Our Ref: BNE220533

Property Location:	417 Sandgate Road, Albion 4010
Application:	A006321182 – Original approval
Property Description:	Lot 1 on RP127006
Development:	S81 Minor Change Request
Client:	Good Karma (Salisbury) Pty Ltd

This Minor Change relates to the approved Multiple Dwelling and seeks to make minor amendments to the approved number of units, car parking and built form. The changes can be summarised as follows:

Approved	Proposed
Site Plan

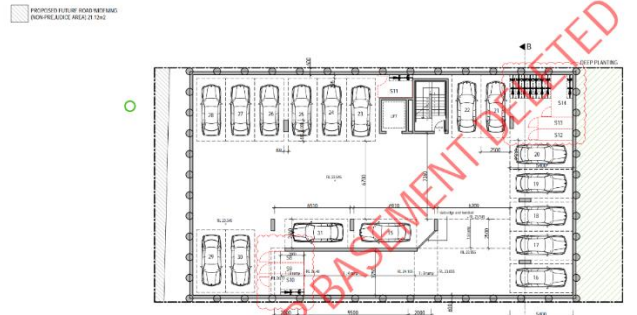
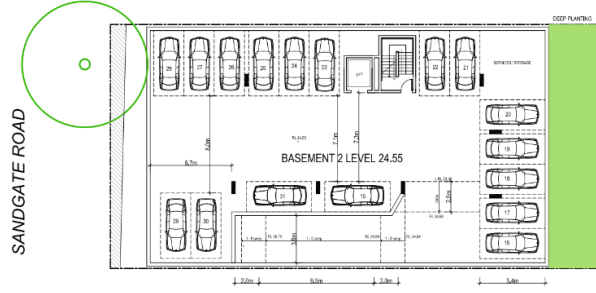
- Increase of the number of units from 15 to 19 units;
- Alignment of the car parking delivery in accordance with the City Frame rates, being:
 - Reduction in resident car parking from 30 spaces to 21 spaces;
 - Reduction in visitor car parking from 4 to 3 spaces;
- Removal of the lower level basement;
- Internal reconfiguration of unit floor plates;
- Minor changes to the ground level to ensure compliant access and manoeuvring and an SRV bay;
- No changes to the number of storeys

Basement Level 1 Plan

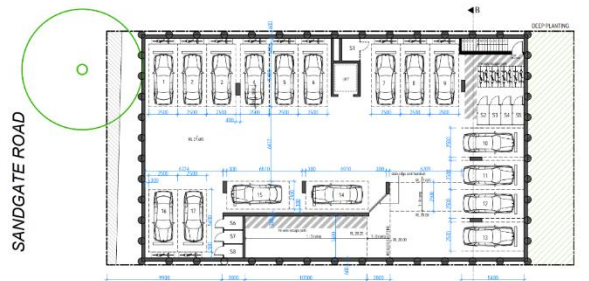
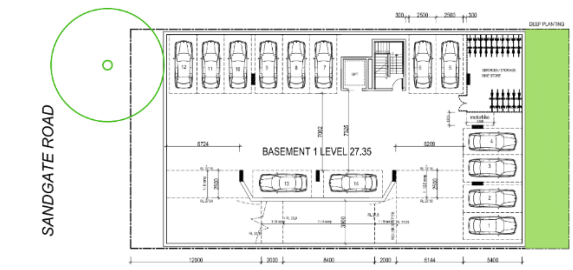
17 car parking spaces were provided on Basement Level 2 within the original approval, which have been removed.

Basement Level 1 now proposes to include 17 car parking spaces instead of the originally approved 13 spaces, including 8 bicycle parking spaces. The Ground Floor Plan now includes an additional 2 resident parking spaces, and a total of 3 visitor spaces reduced from the originally approved 4 visitor spaces. An

Ground Floor Plan

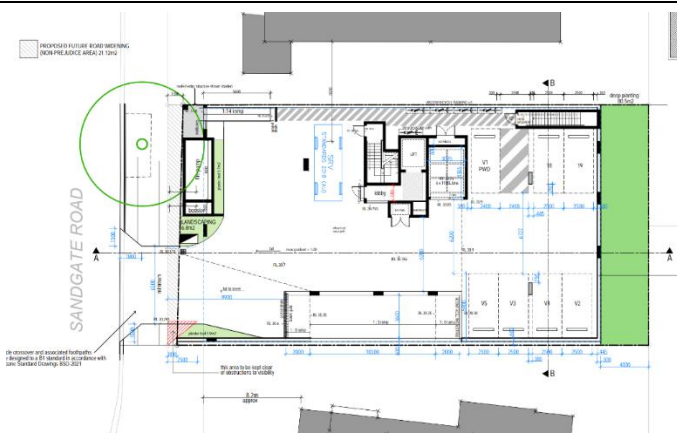
additional 5 visitor bicycle parking spaces are now included on the Ground Floor Plan, along with a reduction in the Lobby and Deep Planting areas.

The Ground Floor Plan initially provided 136.3m² in deep planting areas, which has since been reduced to 80.5m², a reduction of 55.8m². However, this reduction is due to the removal of the deep planting area adjacent the lobby, which was recessed from the street frontage. Additional landscaping area of 17.8m² has been proposed in the new Ground Floor Plans. Refer to **Attachment D** for further information around the landscaping plans. Deep planting remains compliant with the 10% site cover requirement highlighted in the *Brisbane City Plan 2014*.

Level 2 Floor Plan

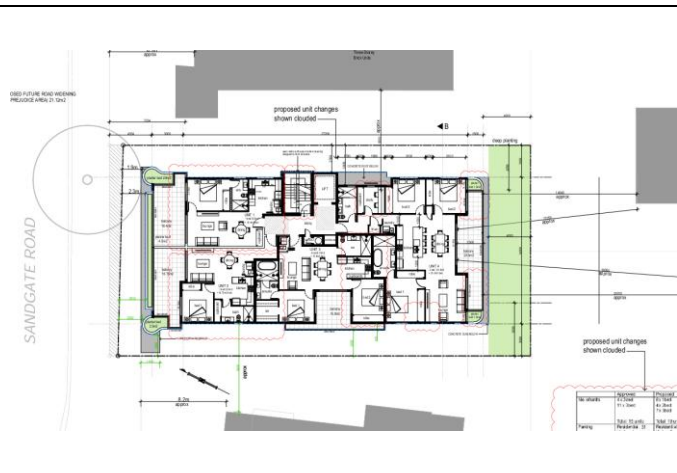
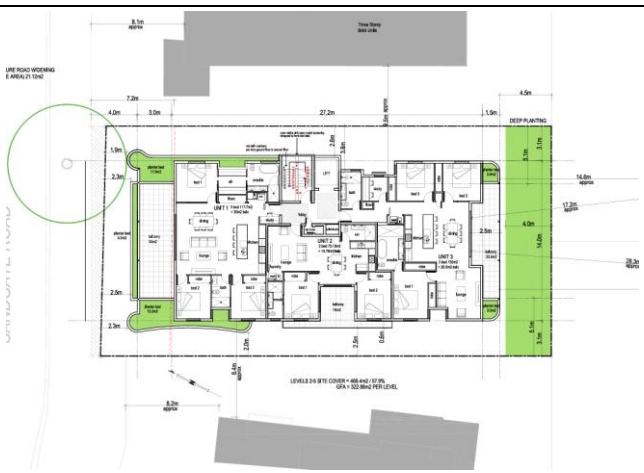
On the Level 2 Floor Plan, an additional unit has been included to provide 4 units on Level 2 instead of the originally approved 3 units.

An additional 4 units have been added to Levels 2-5, providing 16 total units across the levels. Despite the additional units, each unit is able to provide a suitable amount of living space and private open space, with all units exceeding the minimum area requirement of 12m². The additional units provide the development with a variety of choice through the new availability of affordable one-bedroom units.

Figure 1 Originally Approved Exterior Levels 2-5 (Left), Proposed Exterior Changes Levels 2-5

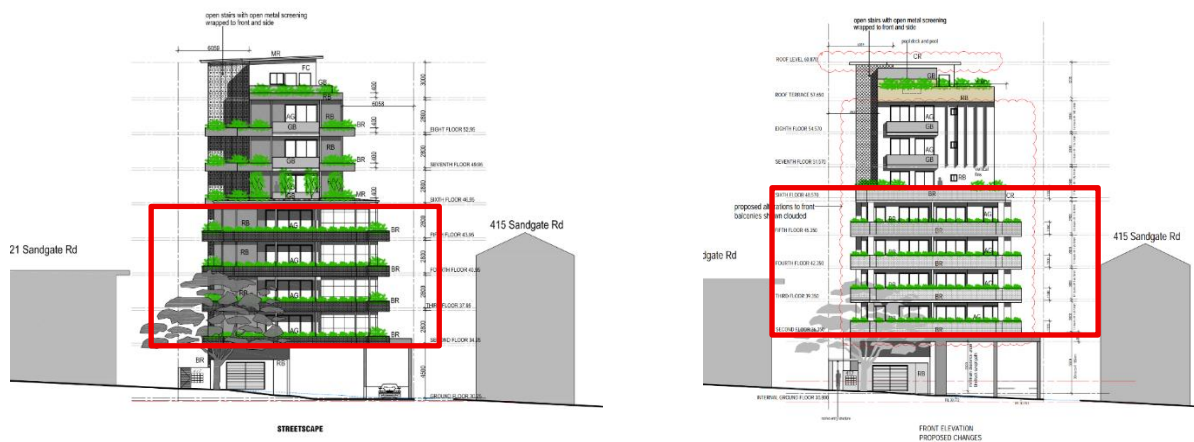
The exterior of Levels 2-5 does not change drastically from the original approval. A portion of the exterior has been altered from rendered brick to glass due to the internal changes to the apartment configuration. The development maintains the general layout of the containerised planting originally included in the approved development, maintaining the positive amenity impacts provided by the proposed green edge around the building. A reduction from 423.5m² to 139m² (84% to 70.2% of overall landscaped area) has been made to the containerised planting layout across the development to ensure all planting is easily accessible by each unit owner from their balcony to reduce the ongoing maintenance burden on the body corporate.

Figure 5 Originally Approved Rooftop Communal Area (Top), Proposed Rooftop Communal Area Changes (Bottom)

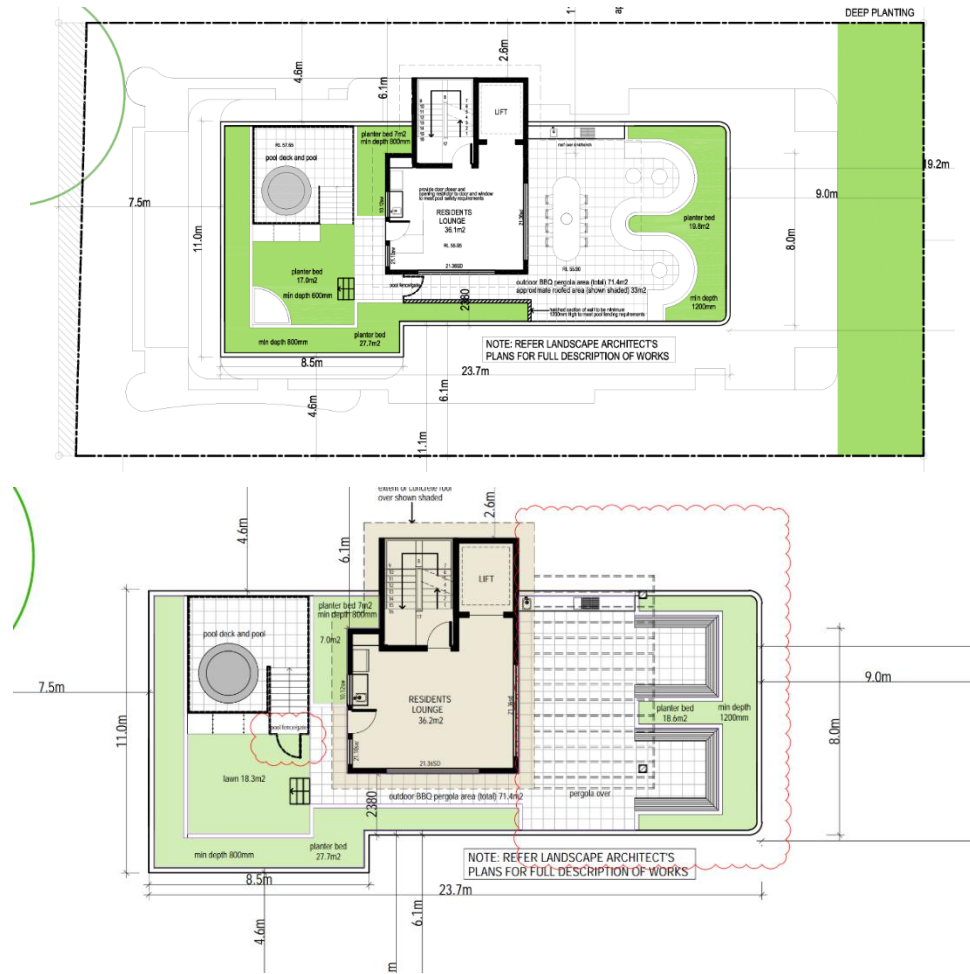
Minor refinements have been made to the rooftop, as well as the addition of a pool deck and pool with the predominant change being to the sunken seating area. The proposal retains the planter beds to the edge of the rooftop.

An increase in landscaped area of 6.6m² is included in the minor changes, providing a variety of planter beds and soft landscaping in the form of a synthetic lawn adjacent to the proposed pool area. All originally included amenities are still provided, specifically the BBQ and outdoor seating area which is included along with a pergola structure and other seating designed as part of some of the planter beds. These major improvements to the communal open space justify the minor reductions of the private open space areas to each unit by providing multiple amenities with the added privacy of being located on the roof of the multiple dwelling.

Figure 6 Infrastructure and Bulk Bin Collection area (left – approved; right – proposed)

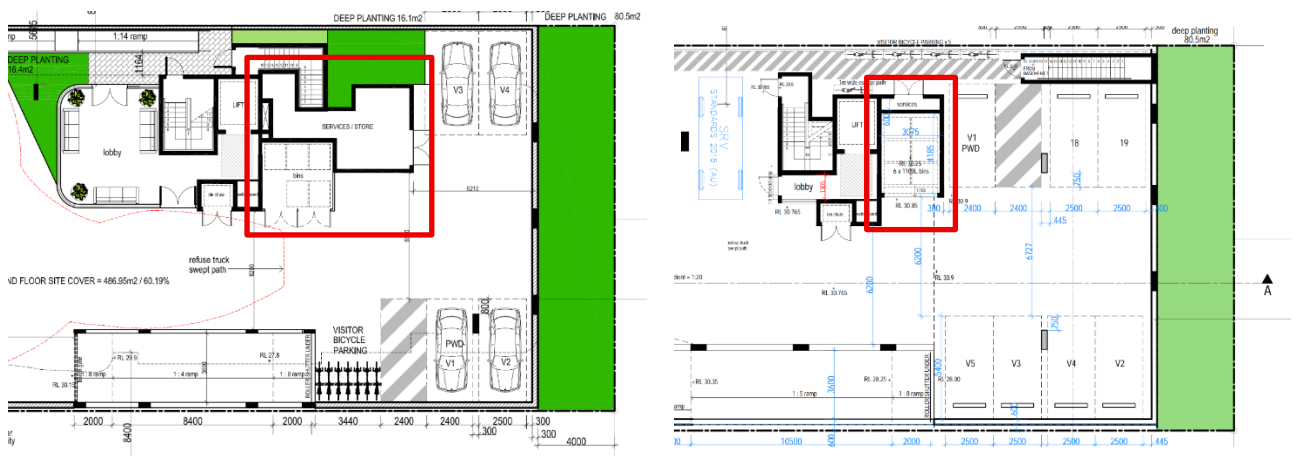
The proposed development generally maintains the existing infrastructure and services to the approved Multiple Dwelling units. The proposed development provides for minor alterations to the approved bulk bin storage area and associated infrastructure services provided next to the Lobby area adjoining the internal hardstand. The proposed alterations do not impact the existing refuse collection arrangements and maintain the required services as currently approved. Where the proposed development provides for amendments to the infrastructure provided on site, it is not considered distinctly different and ensures that all uses are adequately supported by internal infrastructure. An SRV bay is also provided adjacent the lobby entrance.
